**To:** Departments Concerned  
**From:** Alan Stephenson  
Planning & Development Department Director  
**Date:** September 21, 2021  
**Subject:** **P.H.O. APPLICATION NO. PHO-2-21--Z-47-19-7** – Notice of Pending Actions  
by the **Planning Hearing Officer**

**APPLICATION NO: PHO-2-21--Z-47-19**

**Request For:** Stipulation Modification

**Re: Request for Planning Hearing Officer Approval / Z-47-19**

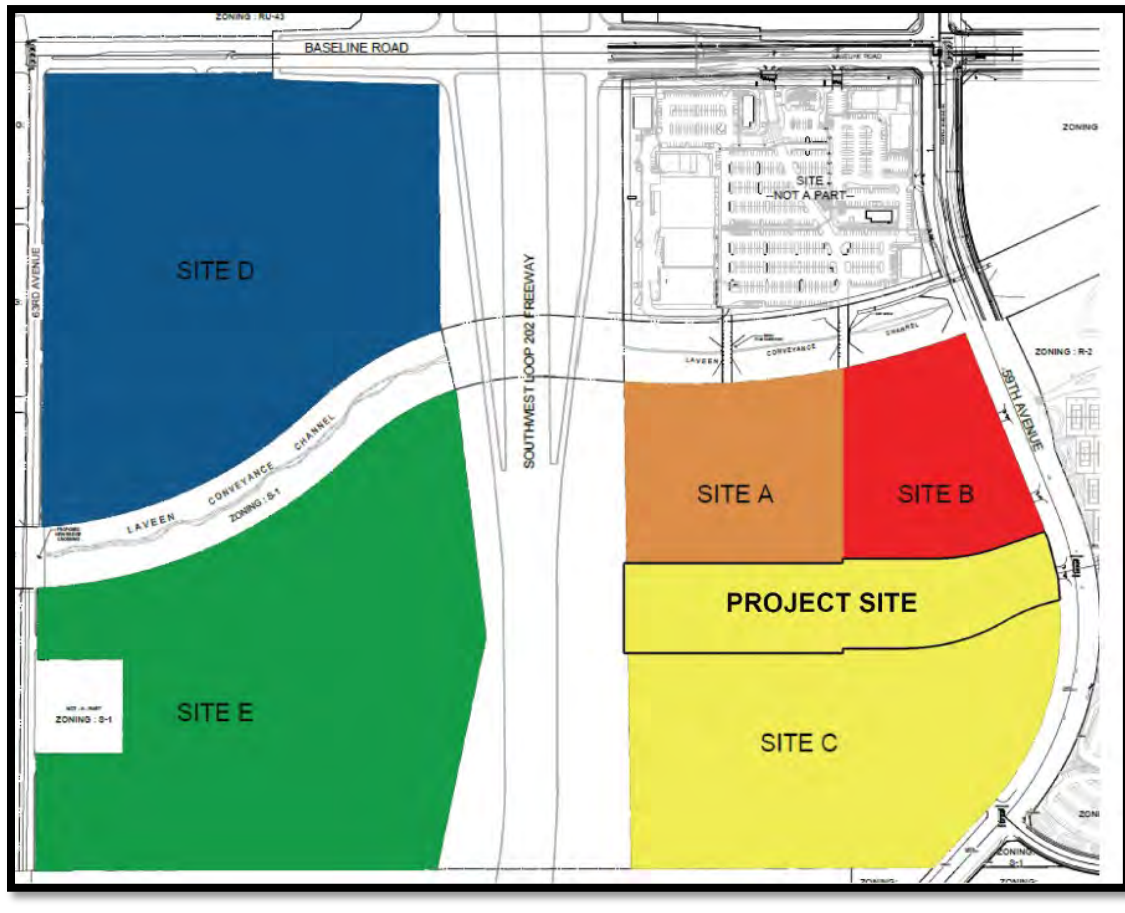
- #1 The development shall be in General Conformance to the Conceptual Master Site Plan date stamped ~~October 23, 2019~~ SEPTEMBER 02, 2021, with specific regard to the site locations, as approved by the Planning and Development Department.**

**Response:** To best address the proposed multi-family development, the expansion of "Site C" to the north to encompass this Site is proposed. As part of the original zoning case, it was envisioned to have multi-family adjacent to the commercial development with pedestrian connectivity. By extending the "Site C" area to the north, the original intent will be maintained while allowing for compliance with all original stipulations for "Site C".

Proposed Site Plan

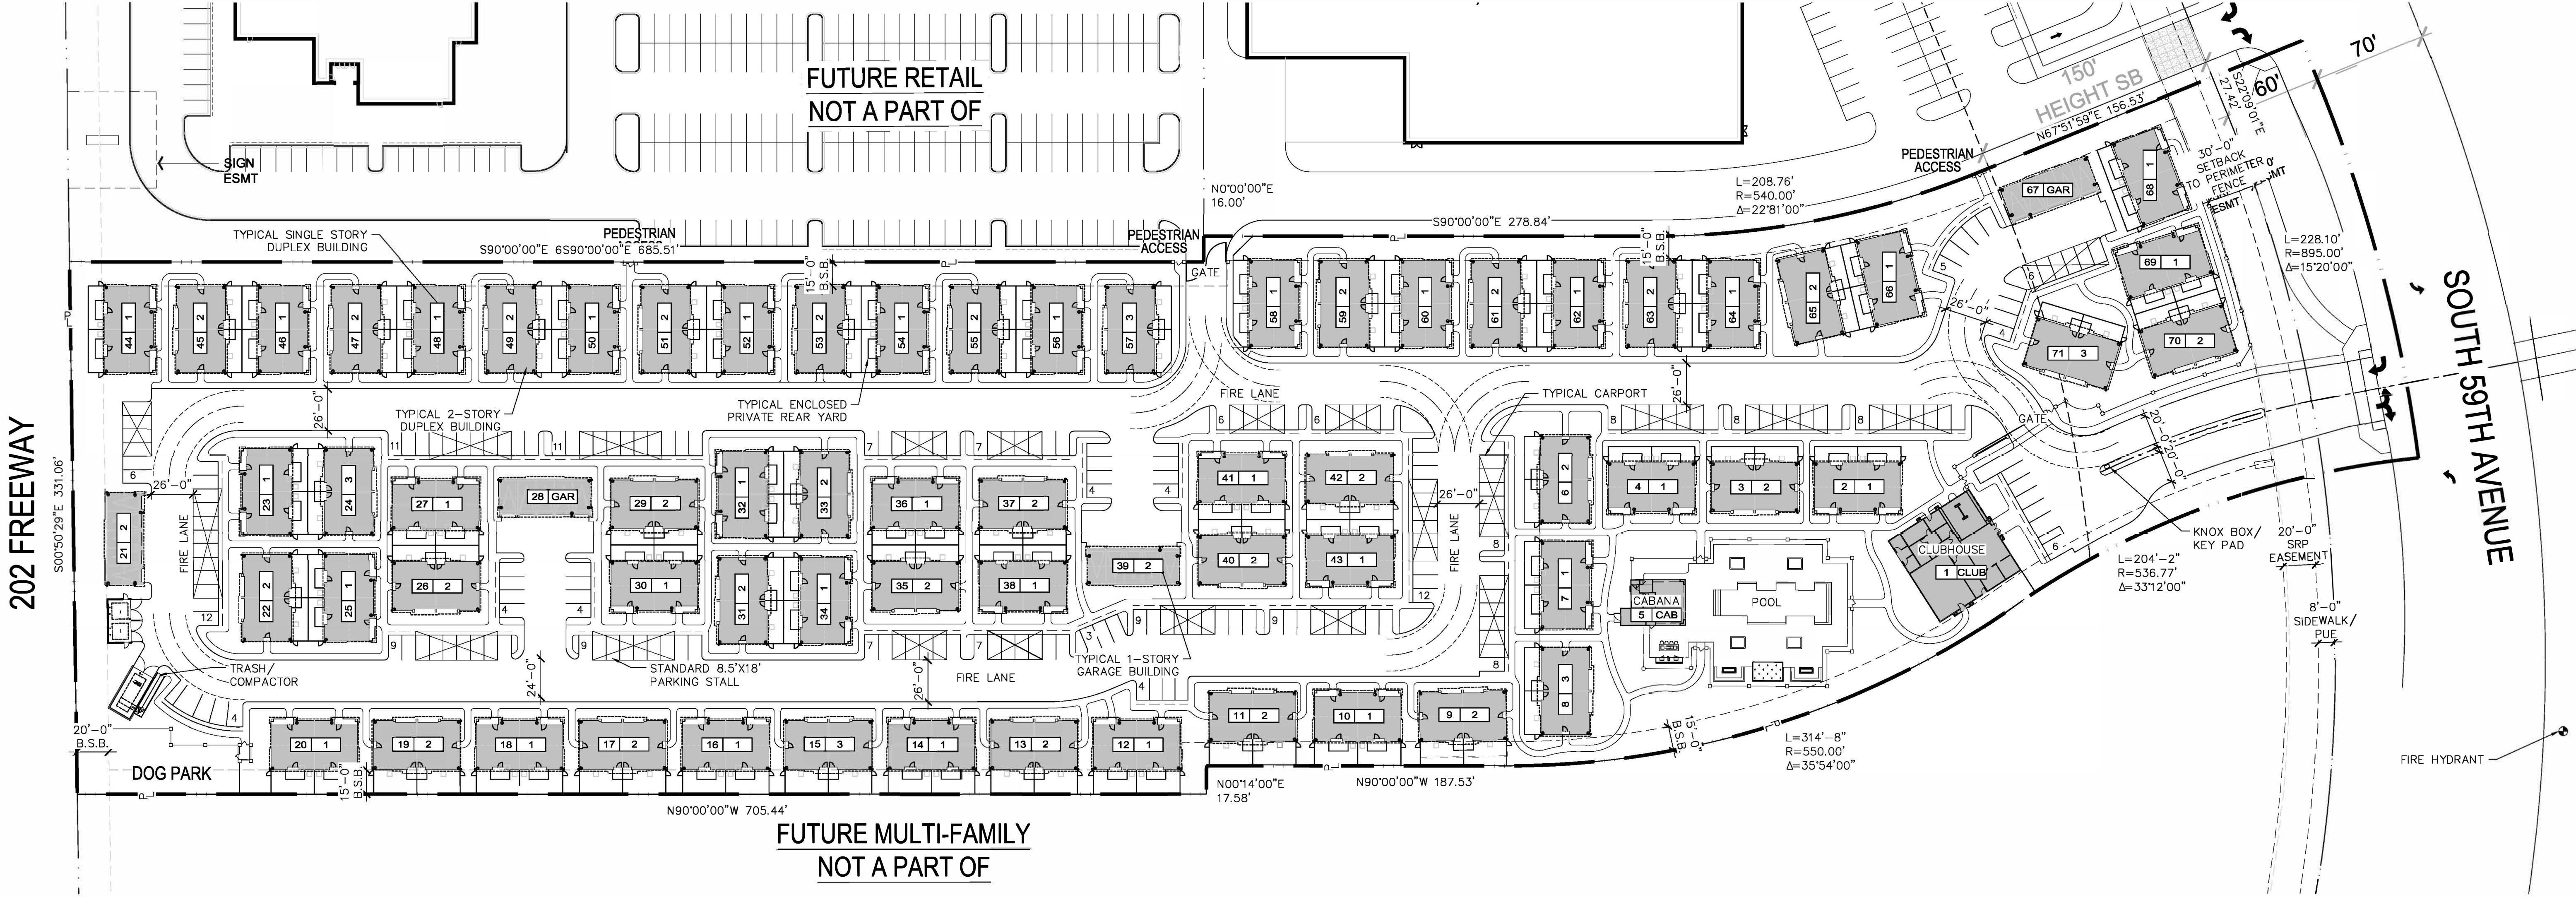
**Response:** As proposed, Ascend at South Mountain includes three evenly spaced pedestrian connections to the future commercial development to the north. The shaded pathways feature self-closing, ADA compliant pedestrian gates. An interconnected network of pathways traverse the Site so that residents can safely and comfortably travel to and from the commercial development, encouraging synergy between the land uses. Additionally, a separated sidewalk is located along 59<sup>th</sup> Avenue connected to internal pathways so that residents can easily leave the Site to access the adjacent bus stop, bike or walk or surrounding properties, etc.
